Docket No. 50-237

DRESDEN NUCLEAR POWER STATION UNIT 2

Amendment No. 7  
License No. DPR-19

ATTACHMENT TO LICENSE AMENDMENT NO. 7  
CHANGE NO. 33 TO THE TECHNICAL SPECIFICATIONS  
FACILITY OPERATING LICENSE NO. DPR-19

Figure 1.1.1. Core Thermal Safety Limit

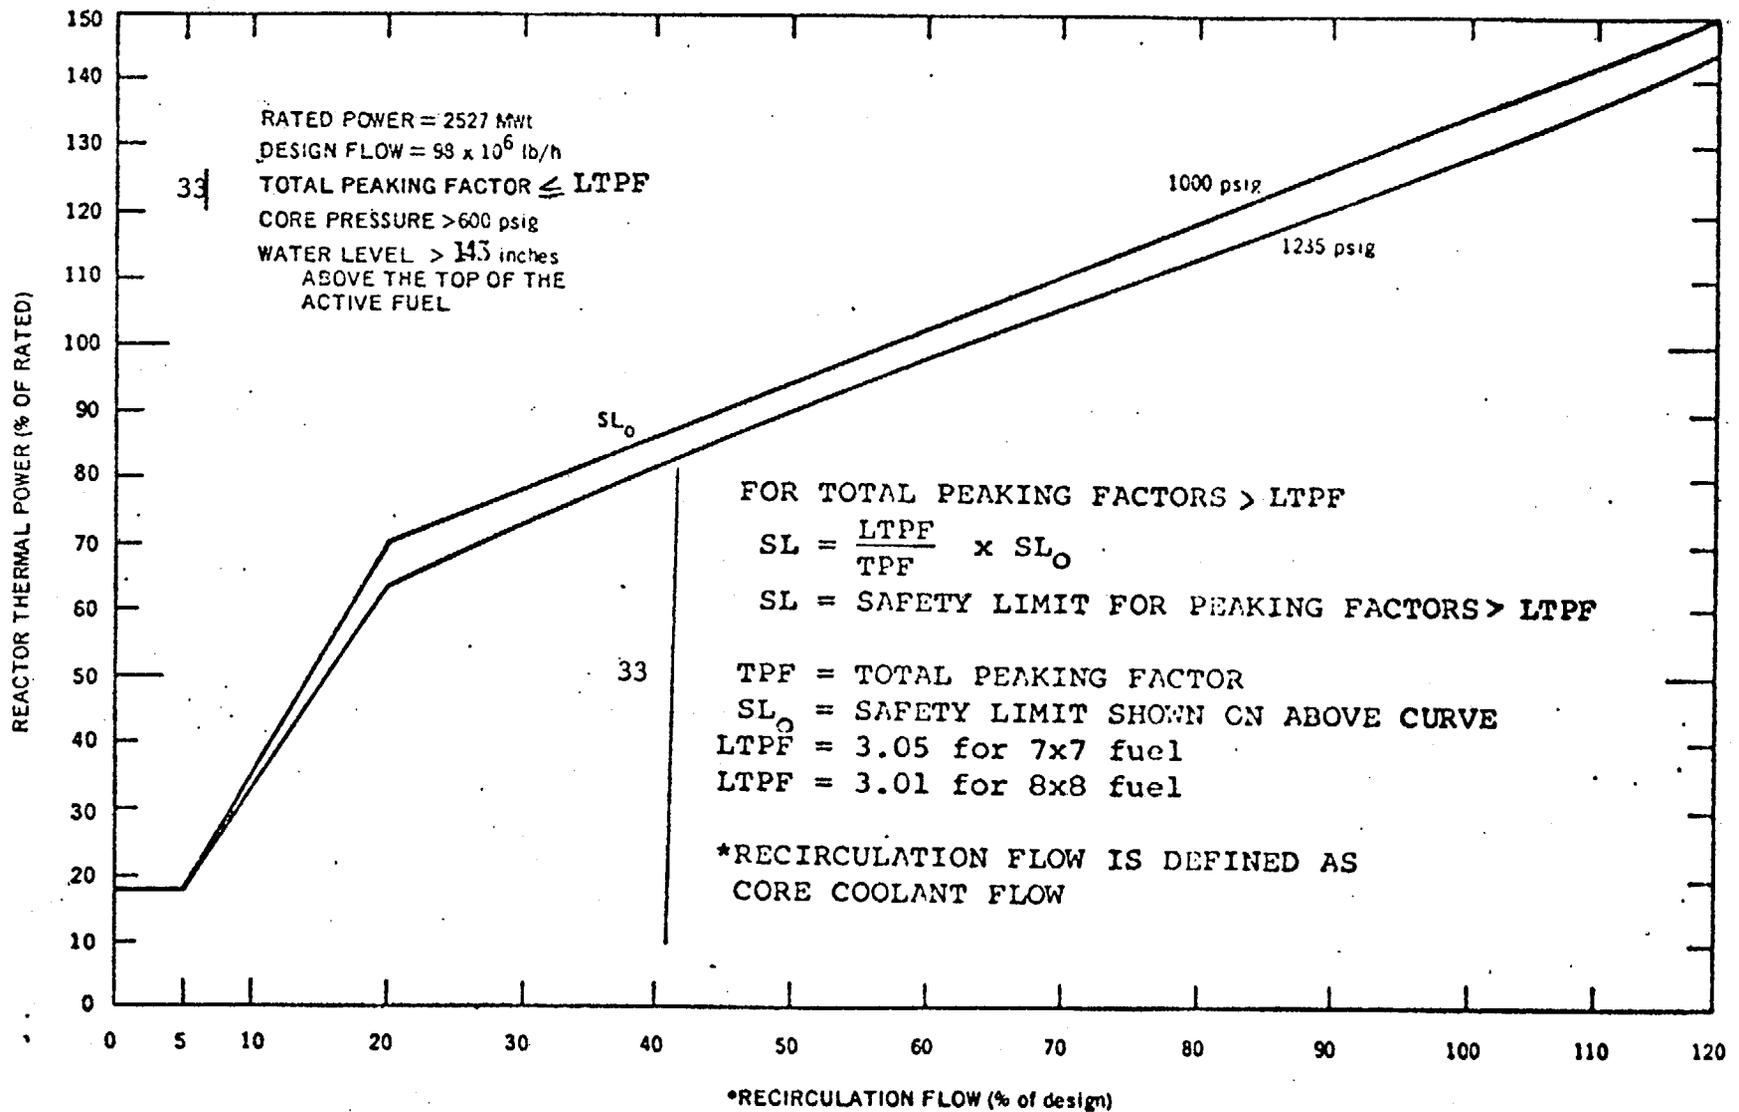
- A. When the reactor pressure is greater than 600 psig the combination of recirculation flow and reactor thermal power-to-water shall not exceed the limit shown in Figure 1.1.1. The safety limit is exceeded when the recirculation flow and thermal power-to-water conditions result in a point above or to the left of the limit line.
- B. When the reactor pressure is less than 600 psig or recirculation flow is less than 5% of design, the reactor thermal power-to-water shall not exceed 460 MW(t).
- C. 1. The neutron flux shall not exceed the scram setting established in Specification 2.1.A for longer than 1.5 seconds as indicated by the process computer.
2. When the process computer is out of service, this safety limit shall be assumed to be exceeded if the neutron flux exceeds

The thermal hydraulic safety limit of Specification 1.1 was based on the Limiting Total Peaking Factor. A factor has been included on Figure 1.1.1 to adjust the safety limit in the event peaking factor exceeds the Limiting Total Peaking Factor. Likewise, the scram setting should also be adjusted to assure MCHFR does not become less than 1.0 in this degraded situation. This has been accomplished by use of Figure 2.1.2. If the combination of power and LHGR is greater than that shown by the curve, the APRM scram setting is adjusted downward by formula given in the specification. The scram setting as given by

Figure 2.1-2 Peak LHGR Versus Core Thermal Power for a Limiting Total Peaking Factor (LTPF)

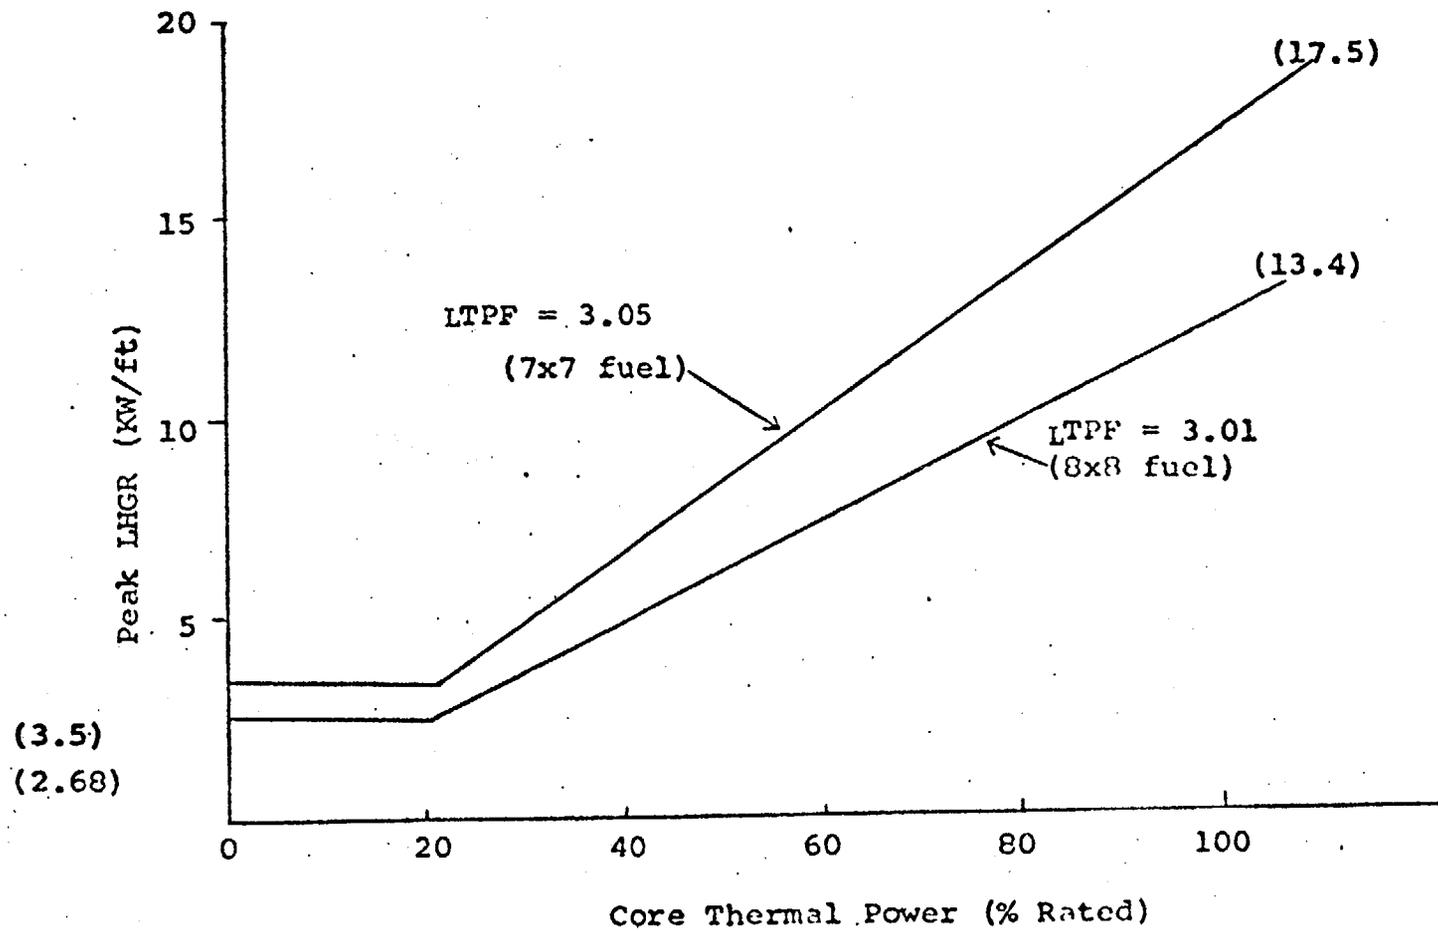
1. APRM - When the reactor mode switch is in the run position, the APRM flux scram setting shall be as shown in Figure 2.1.1 unless the combination of power and peak LHGR is above the curve in Figure 2.1.2. When the combination of power and peak LHGR is above the curve in Figure 2.1.2 a scram setting(s) as given by:

TPF = LTPF unless the combination of power and peak LHGR is above the curve in Figure 2.1-2 at which point the actual peaking factor value shall be used.

- B. APRM Rod Block - The APRM rod block setting shall be as shown in Figure 2.1.1 unless the combination of power and peak LHGR is above the curve in Figure 2.1.2. When the combination of power and peak LHGR is above the curve in Figure 2.1.2 a rod block trip setting ( $S_{RB}$ ) as given by:

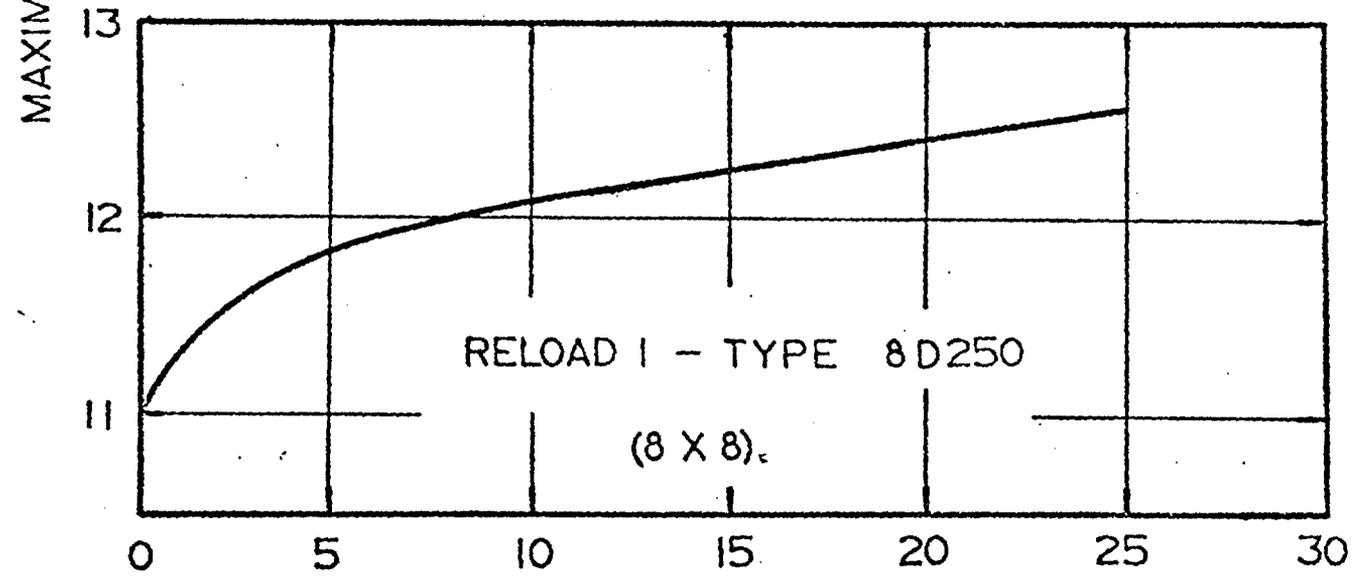
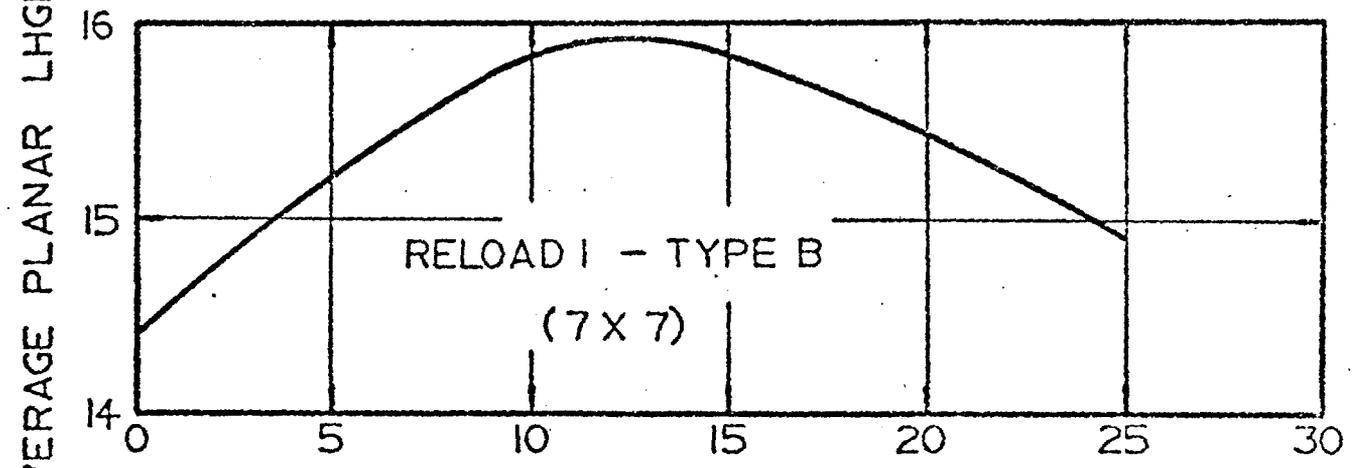
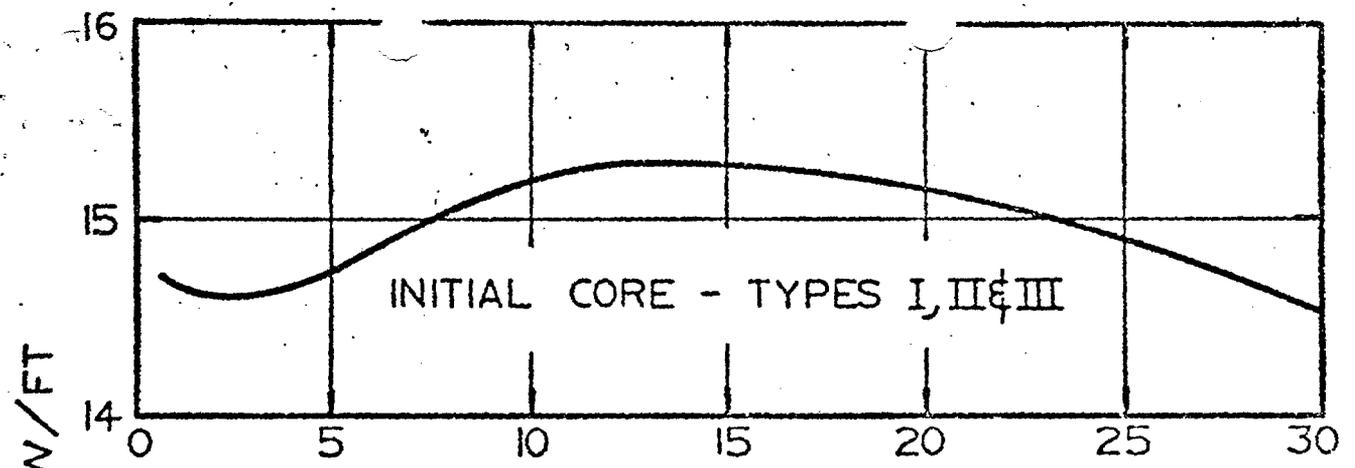
During steady state power operation, the average linear heat generation rate (LHGR) of all the rods in any fuel assembly, as a function of average planar exposure, at any axial location, shall not exceed the maximum average planar LHGR shown in Figure 3.5.1.

The maximum average planar LHGR curves related to the Interim Acceptance Criteria for the 7 x 7 and 8 x 8 reload fuel assemblies have been added in accordance with the Commission's regulations. The methods used to calculate appropriate MAPLHGR limits related to the Interim Acceptance Criteria are the methods previously approved by the staff(1). As indicated above, we will subsequently address consideration of 10 CFR 50.46.

Daily during reactor power operation, the average planar LHGR shall be checked.
